INITIAL FIRE SAFETY INSPECTION REPORT

Ripon Knitwear Ltd (Extension)

RSC ID: 26604

Date: 07-May-2026

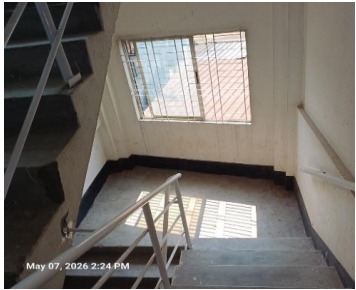
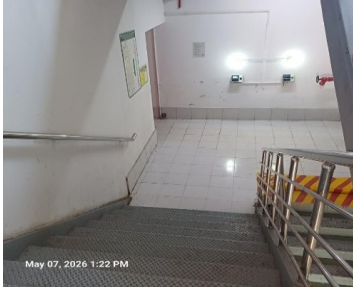
F-04	Means of Egress	Stair clear width was found less than 60 in. Location(s): North-East Stair (2)-46"; South Stair (3)-43", South-West Stair (4)- 38" (Building-4, 5 & 6).	Stairs shall have a minimum clear width of 60 in. in for all industrial occupancies as per RSC Technical Guideline (Standard) section 6.5.6.	Within 3 Months
		 May 07, 2026 2:24 PM	 May 07, 2026 2:32 PM	 May 07, 2026 1:22 PM

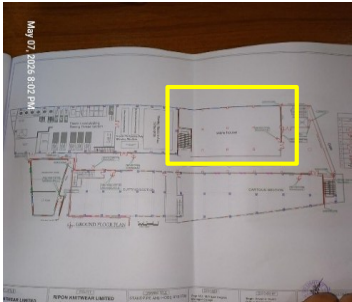
F-06	Means of Egress	Sliding doors have provided along means of egress [along egress routes]. Location(s): Packing areas; Building-5.	Replace all collapsible/sliding/shutter type doors & gates by the side-hinged swinging type doors in accordance with section 6.8.1 of RSC Technical Guidelines (Standard)¹ V1.0. All doors in a means of egress shall be of the side-hinged swinging type. Roll--down and sliding gates and shutters shall not be allowed. Doors serving an occupant load of more than 50 shall swing in the direction of egress travel.	Within 1 Month

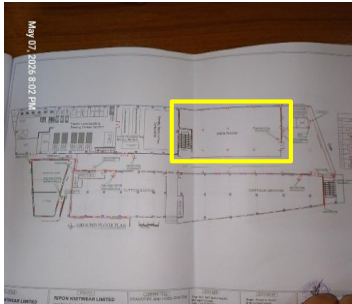
F-07	Means of Egress	AC Outdoor were located in the exit stair enclosure. Location(s): South-West Stair (4).	Remove and re-locate all AC Outdoor/Electrical panels/water pump/food cabinet/shoe cabinet/Toilet from exit stair enclosures. Or, Provide fire separation with stair enclosure in accordance with section 6.3.1 of RSC Technical Guidelines (Standard)¹ V1.0.	Within 1 Month

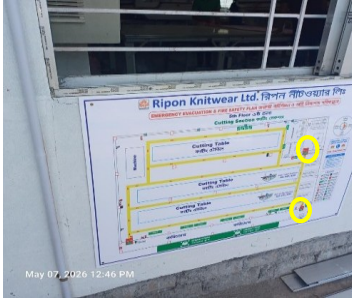
F-08	Means of Egress	Egress door serving 50 or more occupants but does not swing in the direction of egress travel. Location(s): Ground and 4th Floor; Building-4, 5 & 6.	Modify swing direction of egress doors to the direction of egress travel. Doors serving an occupant load of more than 50 shall swing in the direction (out-ward) of egress travel in accordance with section 6.8.1 of RSC Technical Guidelines (Standard)¹ V1.0.	Within 1 Month
		 May 07, 2026 1:21 PM	 May 07, 2026 4:00 PM

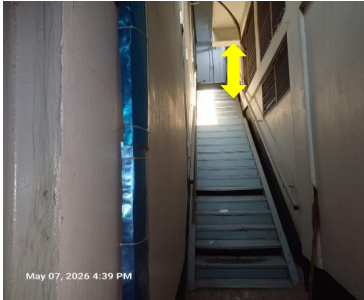
F-09	Means of Egress	Exit access corridor(s) serving more than 30 occupants is not separated by fire rated construction or protected by sprinkler system in accordance with NFPA 13 and section 6.3.1.1 of RSC Technical Guidelines (Standard)¹ V1.0. Location(s): 5th Floor; Building-6.	1. Separate the exit access corridor by a minimum 1-hr fire rated construction . Or 2. Provide automatic sprinkler system throughout the storey as per NFPA 13.	Within 3 Months

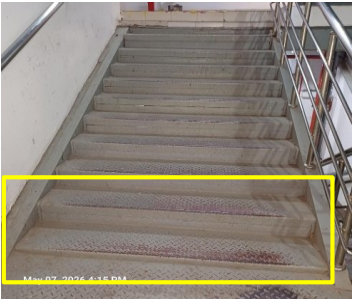
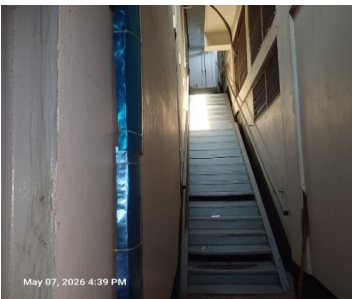
F-10	Means of Egress	Exit stair(s) terminates the occupants inside the building which does not comply with section 6.17 of RSC Technical Guidelines (Standard)¹ V1.0. There is a canopy/shed located in West side of Building-4 & 5 and South side of Building-6 which is connected with these buildings on the Ground floor and Non-RSC ID shed Ripon Packaging Ltd. without any fire separation. Location(s): All stairs, Building-4, 5 & 6.	Exits shall discharge directly to the exterior of the building unless meeting the requirements of 6.17.2 or 6.17.3 as per RSC Technical Guidelines (Standard)¹ V1.0.	Within 3 Months
 May 07, 2026 5:15 PM  May 07, 2026 4:56 PM  May 07, 2026 5:02 PM

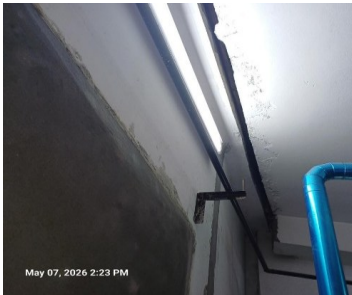
F-19	Means of Egress	Based on the number and location of emergency lights observed, adequate illumination levels are not anticipated along egress routes. Location(s): Building-4, 5 & 6.	Test the emergency lighting system on each floor and provide additional emergency fixtures to provide adequate illumination along the means of egress. Provide a minimum illumination of 10 lux at the floor level within exit stairs and exit discharge paths, and minimum 2.5 lux along exit access aisles. Illumination on means of egress shall meet in accordance with RSC Technical Guidelines (Standard)¹ V1.0 Section 10.12.2.	Within 3 Months

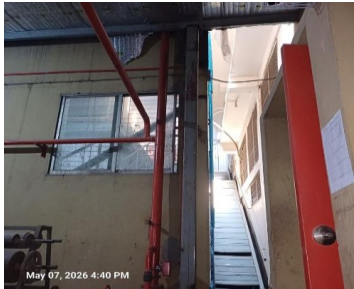
F-21	Means of Egress	Building does not have stair and floor level designation signs at required locations on all floors. Location(s): Building-4, 5 & 6.	Provide stair designation sign at each floor entrance from the stair to the floor in English and Bengali. Signs shall indicate the name of the stair and the floor level. Signs shall be posted adjacent to the door in accordance with RSC Technical Guidelines (Standard)¹ V1.0 Section 6.9.3.	Within 1 Month

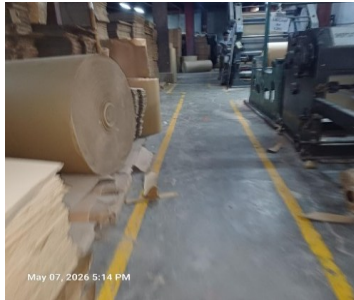
F-23	Means of Egress	Parapets or guards are provided in occupiable roof which height is less than 42 in. Location(s): Building-4, 5 & 6.	Provide parapets or guards with a minimum height of 1067mm (42 inch.) in accordance with RSC Technical Guidelines (Standard)¹ V1.0 Section 6.12.	Within 3 Months

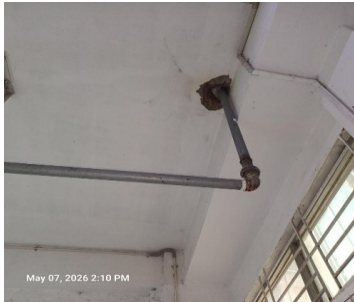
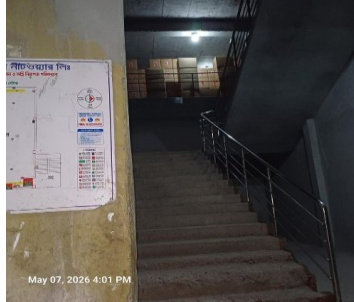
F-25	Fire Rated Construction	Building expansion joint opening is not sealed by fire rated sealant/material. Location(s): Building-4, 5 & 6.	Expansion and contraction joints provided to accommodate expansion, contraction, wind or seismic movement shall be protected with a listed material having the same degree of fire resistance as that of the wall or floor in which it is installed. Installation shall be as per manufacturer published installation guideline and the certification authority guideline to ensure the fire-rating.	Within 3 Months

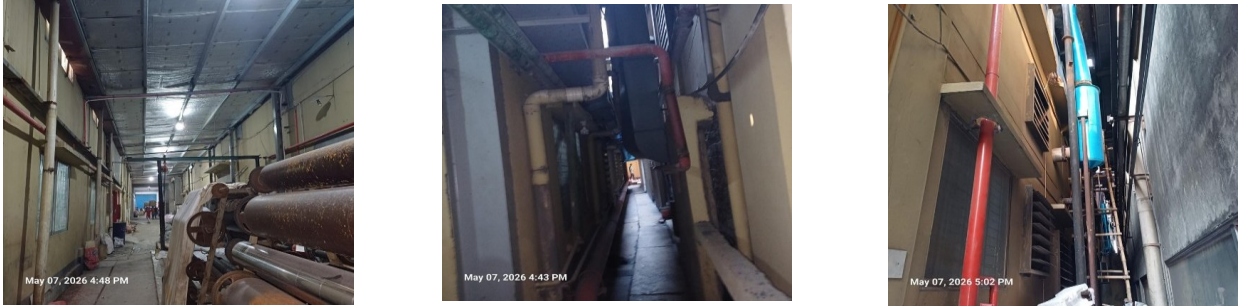
F-27	Fire Rated Construction	Generator and LT panel room is not properly separated by fire rated construction with other Occupancies/Areas. Location(s): Ground floor Building-4.	Generator shall be separated from other occupancies by a minimum 2-hr fire rated construction (wall, floor, slab etc.). Seal all penetrations and openings (door, window etc.) should be protected by 1.5-hr fire rated materials to maintain the fire separation if required. All exhaust systems shall discharge to the exterior of the building in a safe location. Or Relocate it to exterior of the building and maintain a minimum 3m (10 ft.) spatial separation distance from the building. Generator room separation shall meet section 3.4.2.1.2 of RSC Technical Guideline (Standard).	Within 3 Months
 May 07, 2026 4:41 PM  May 07, 2026 4:40 PM  May 07, 2026 5:02 PM

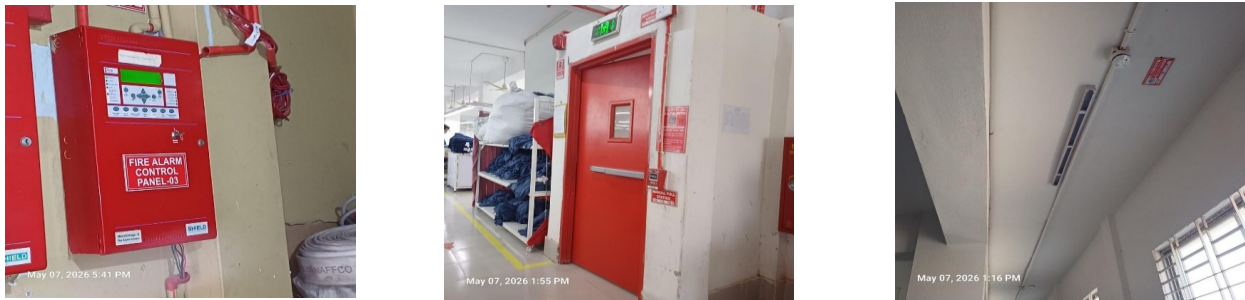
F-28	Fire Rated Construction	Rooms used for storage of combustible materials are not separated from the surrounding occupancy/areas. Location(s): Ground and 1st floor in Building-5 & 6. Unprotected opening, non-rated members of Building-5, non-functionality of fire door, clearance under the bottom of fire door was more than 19 mm, certification was not available for fire rated doors and door accessories, etc.	Rooms used for storage of combustible materials shall be separated from the surrounding occupancy with a minimum 1 hour construction in accordance with section 3.4.2.1.5 of RSC Technical Guideline (Standard).	Within 3 Months
 May 07, 2026 5:15 PM  May 07, 2026 3:58 PM  May 07, 2026 5:17 PM
